# BCA and Access Assessment Report

27A – 29 Pine Avenue, Brookvale

**Reference No:** 114528-BCA-r2

**Date:** 3 June 2022

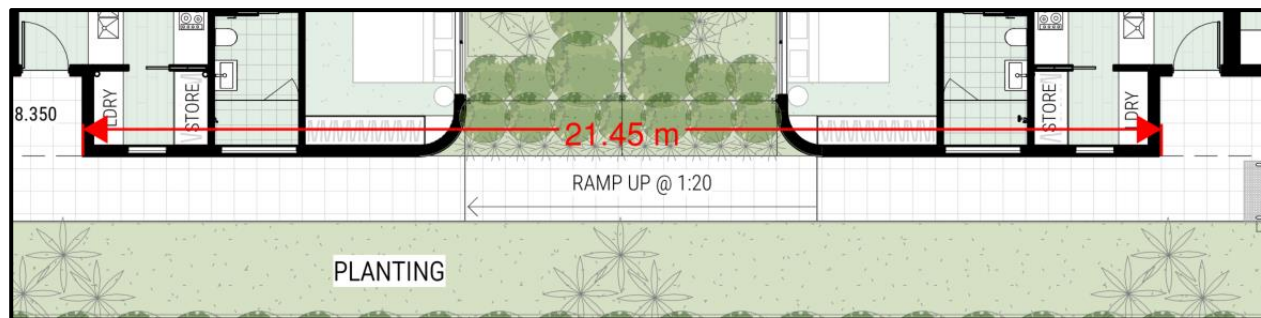
Within the Level 1 of each of the residential storeys, it is noted that there is an extended travel distance of up to 8m to an exit in lieu of the required 6m.

This will need to be modified to be reduced to less than 6m or a Performance Solution may be sought by a Fire Engineer.
